Access Compliance Report

Public Rights-of-Way

(Curb Ramps)

Intersection ID: 47841	Main Street: MANITOBA_LN	Cross Street: ALVARADO_WY	Location:	N
ADA ID: B18EAAFDD74F	Ramp Type: Perp	Initial Pass/Fail: Fail	Overall Compliance: No	Severity Score: 8.75
Codes/Mitigation Info/Possible Solution		Field Measurements/Component Compliance

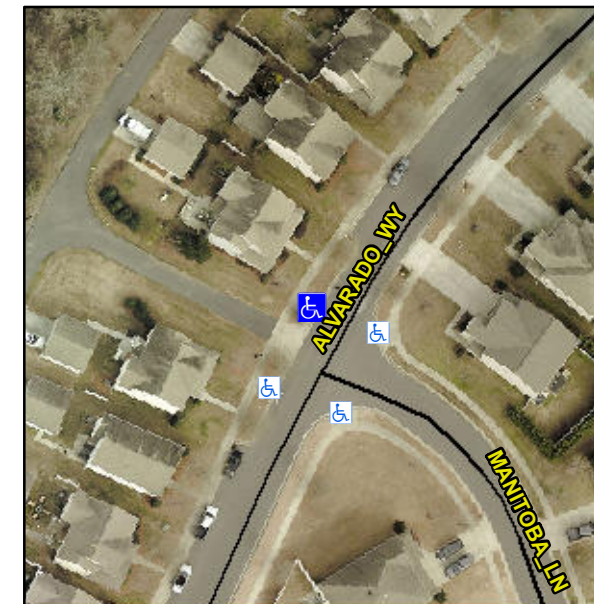
R304.5.1

Compliance	Description	Data	Compliance	Description	Data
N/A	Ramp Length (in)	107.0	Yes	Ramp Slope (%)	7.6
No	Ramp Width (in)	47.0	Yes	Ramp XSlope (%)	0.6
N/A	Flare Type LT	N/A	N/A	Flare Type RT	N/A
N/A	Flare Slope LT (%)	N/A	N/A	Flare Slope RT (%)	N/A
N/A	Flare Traversable LT?	N/A	N/A	Flare Traversable RT?	N/A
N/A	Landing Length (in)	N/A	N/A	DWS Provided?	N/A
N/A	Landing Width (in)	N/A	N/A	DWS Contrast?	N/A
N/A	Landing Slope (%)	N/A	N/A	DWS Length (in)	N/A
N/A	Landing X Slope (%)	N/A	N/A	DWS Full Width?	N/A
N/A	Landing Curb? (Y/N)	N/A	N/A	DWS Offset (in)	N/A
N/A	Shared Landing?	N/A			
N/A	Gutter Ponding?	N/A	N/A	Gutter Slope (%)	N/A
N/A	Gutter Lip Ht (in)	N/A	N/A	Gutter X Slope (%)	N/A
N/A	Painted X Walk1?	No	N/A	Painted X Walk2?	N/A
	X Walk 1 Direction	To SE		X Walk 2 Direction	N/A
N/A	X Walk 1 Width (in)	N/A	N/A	X Walk 2 Width (in)	N/A
	X Walk 1 Slope (%)	0.5		X Walk 2 Slope (%)	N/A
	X Walk 1 X Slope (%)	1.2		X Walk 2 X Slope (%)	N/A

Remove & Replace Entire Ramp.
